DOCUMENT CONTROL PROCESSING FORM

File Number:	DESN0218 Item No. 02		
Document Date:	12/21/21		
Document Type:	Plans		
DCPF Author:	Rachel Altona		
Subject:	Final: Drainage Plans and Profiles		
To (Company):	WSDOT	To (Individual):	Wendi Dubach / Feather Gordon
From (Company):	Jacobs	From (Individual):	Heather Weeks
Additional Subject Information and/or Keywords		Schedule Activity:	N/A

SR509
I-5 TO 24TH AVENUE S
NEW EXPRESSWAY

DRAINAGE PLAN

PLAN REF NO
DR24

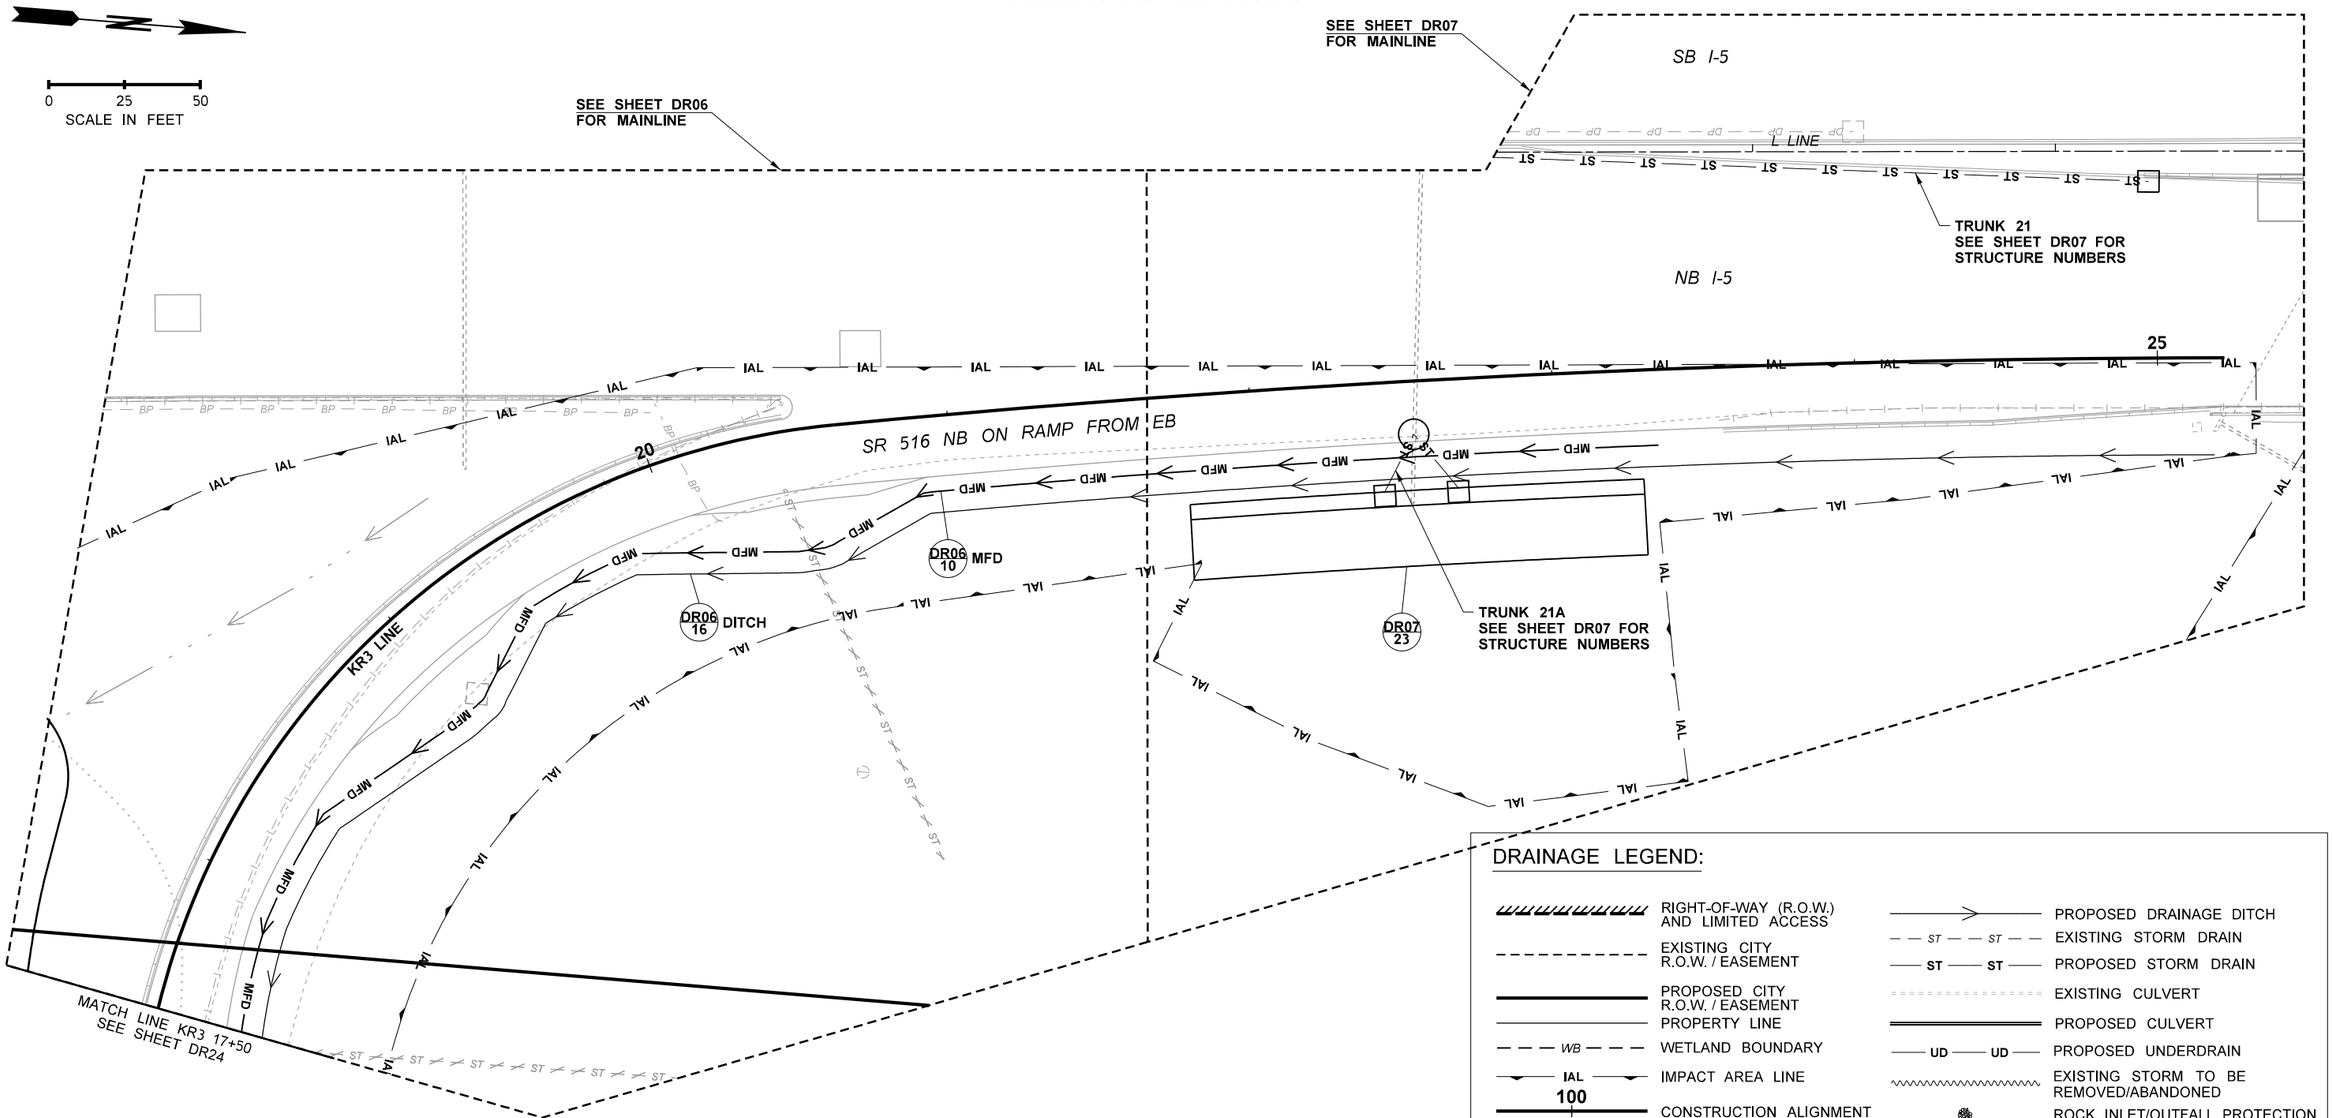
Please label culvert and add inlet/outlet protection.

PLAN REF. NO. DP01

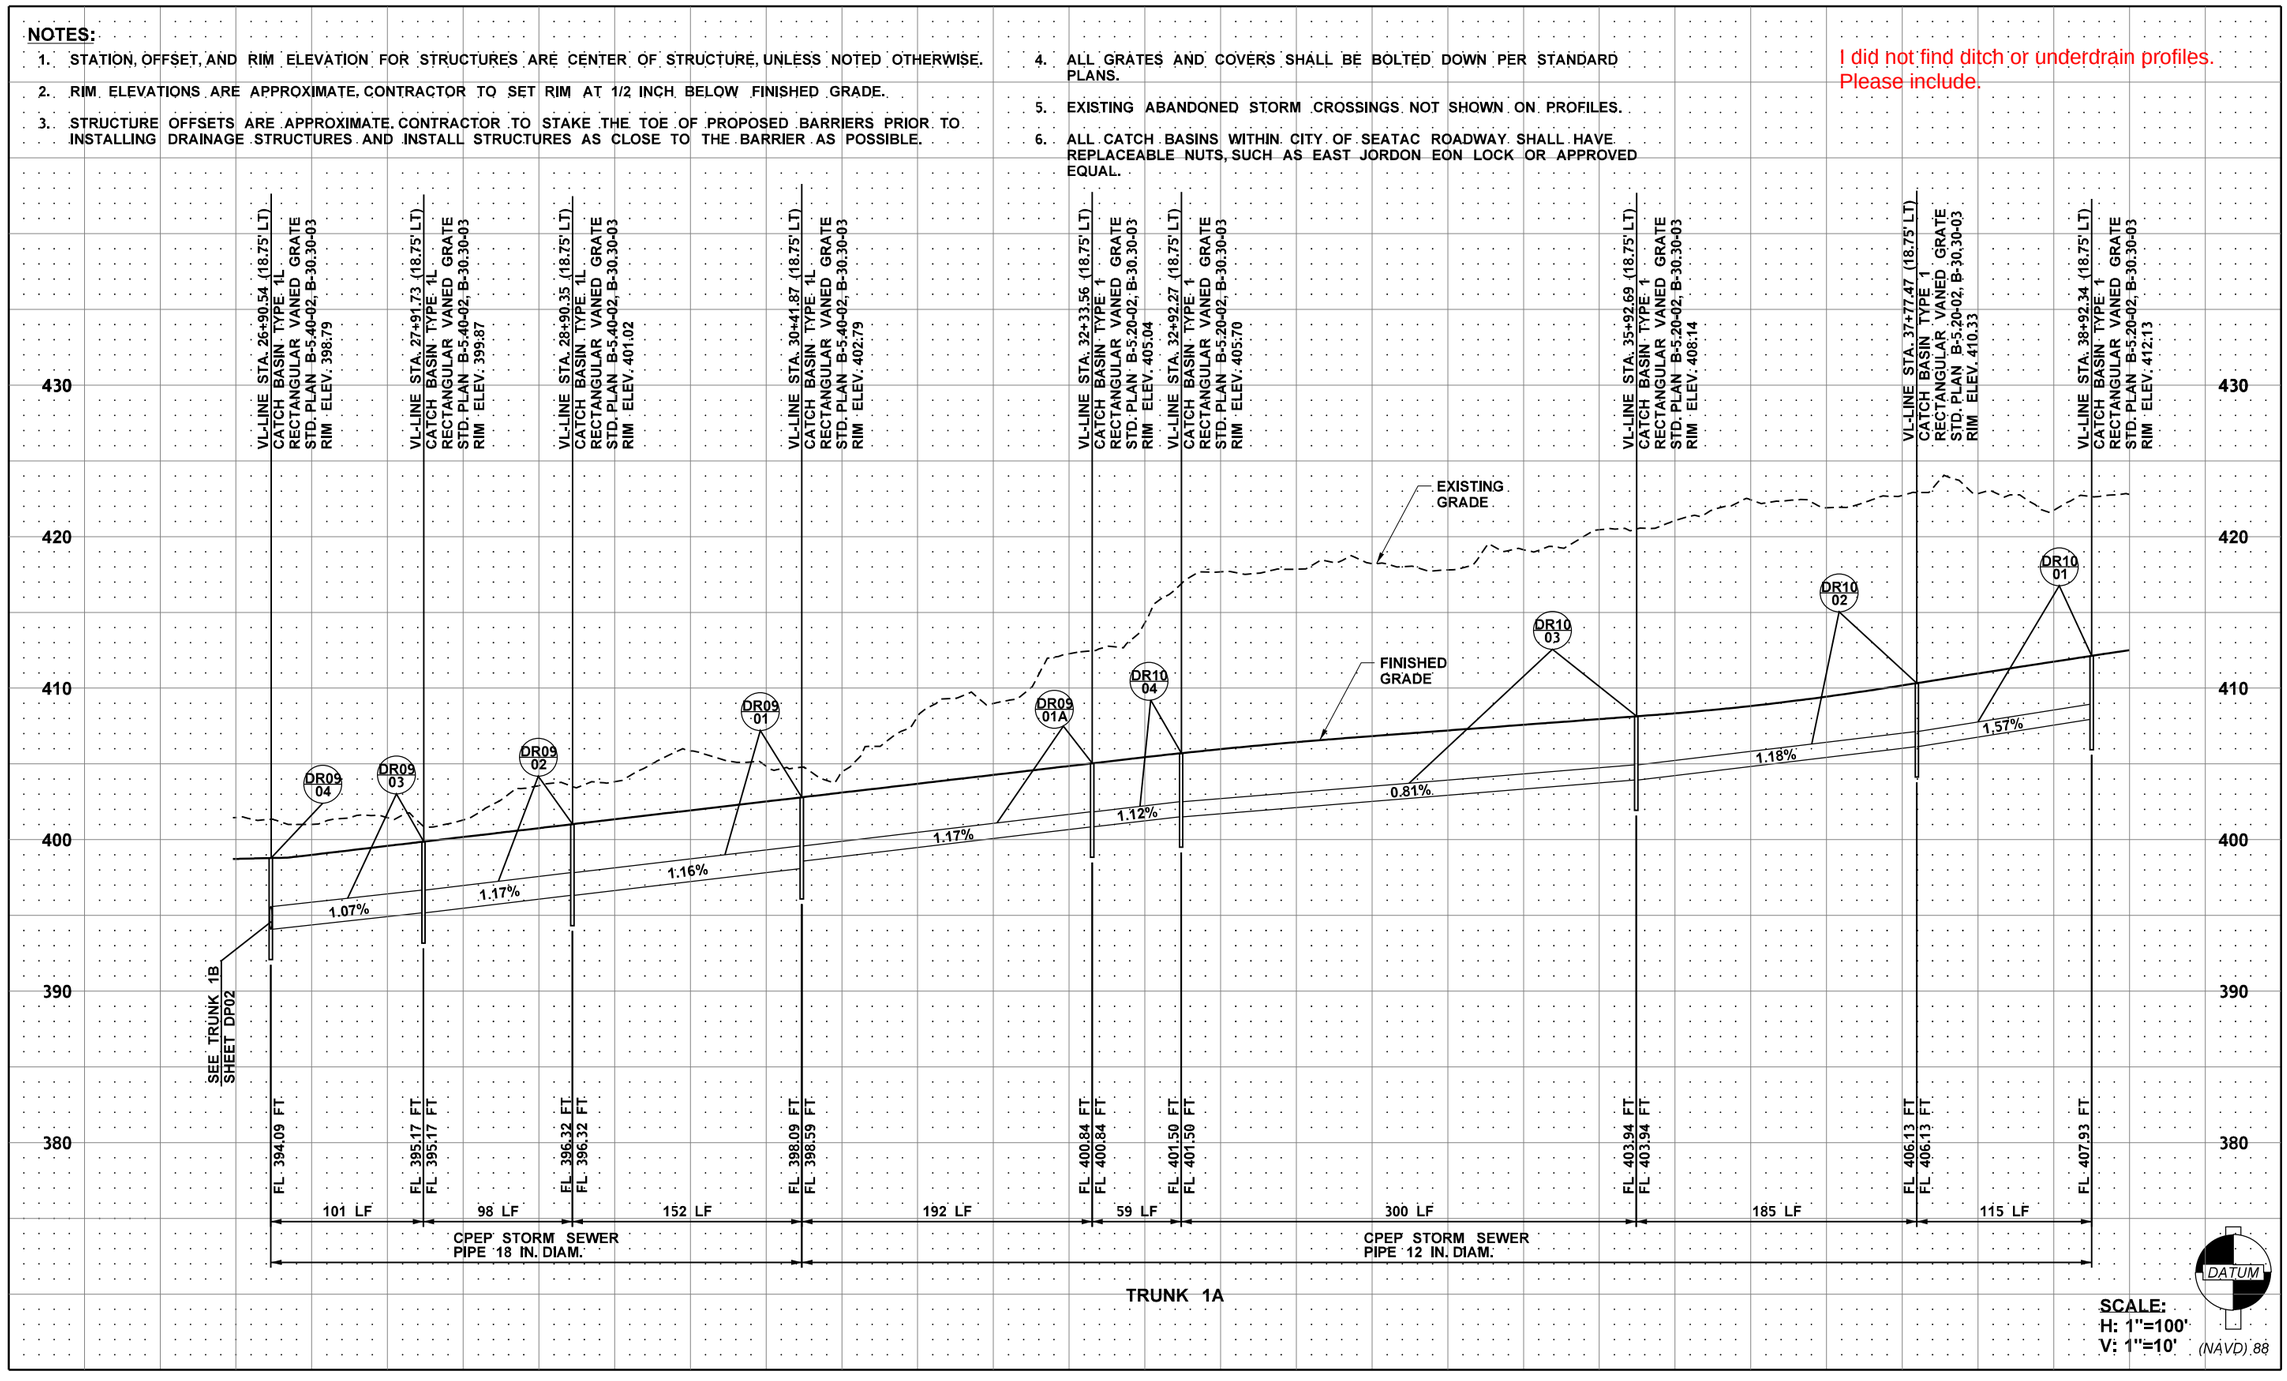
I did not find ditch or underdrain profiles. Please include.

PLAN REF. NO. DP02

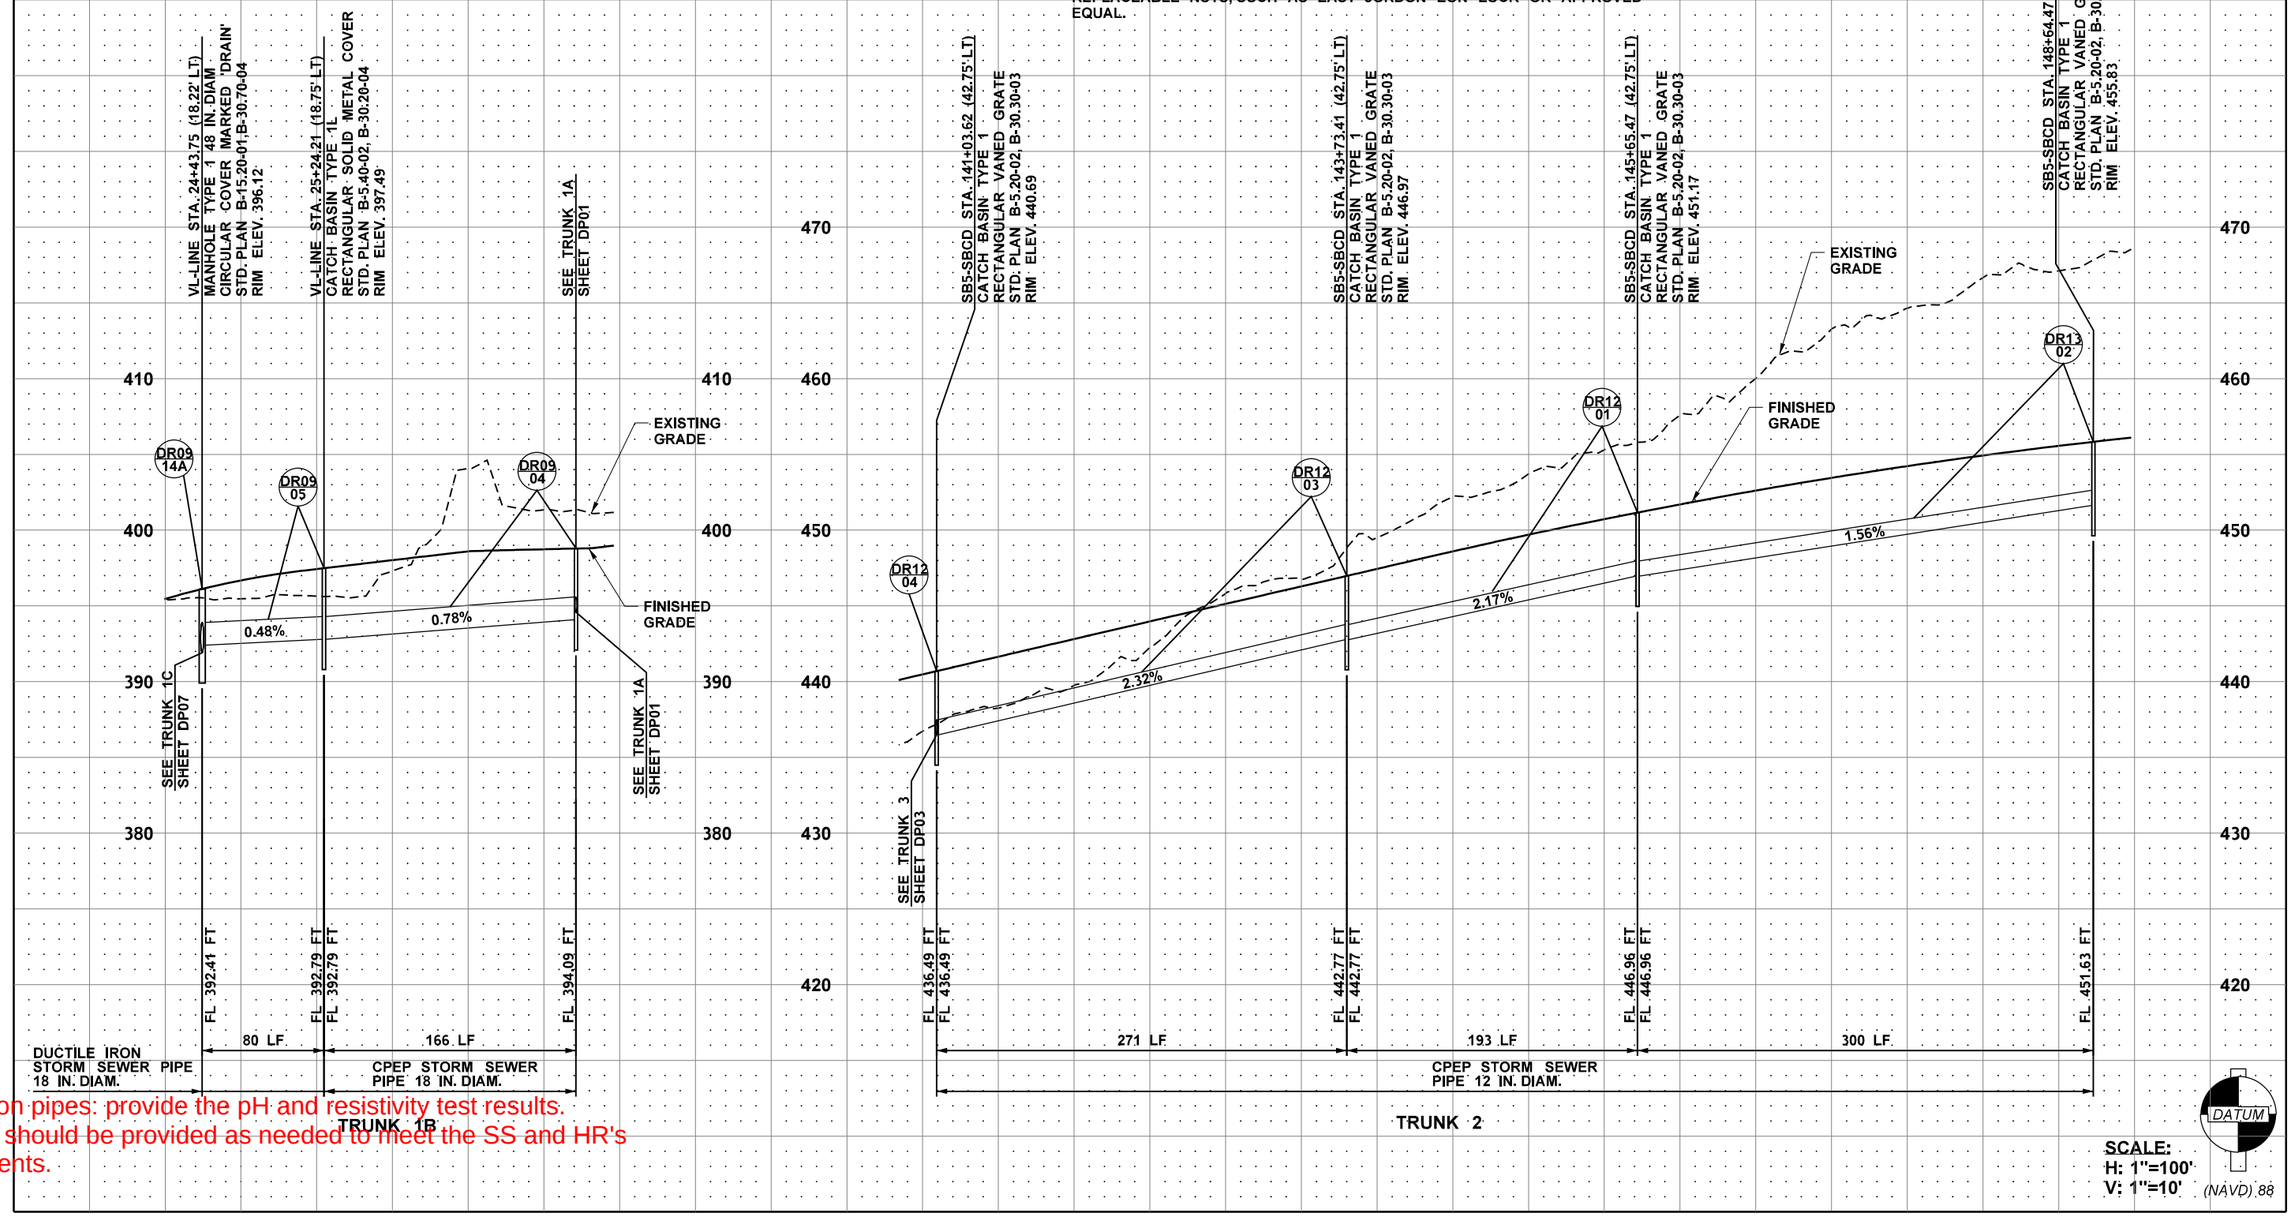
Ductile iron pipes: provide the pH and resistivity test results. Coatings should be provided as needed to meet the SS and HR's requirements.
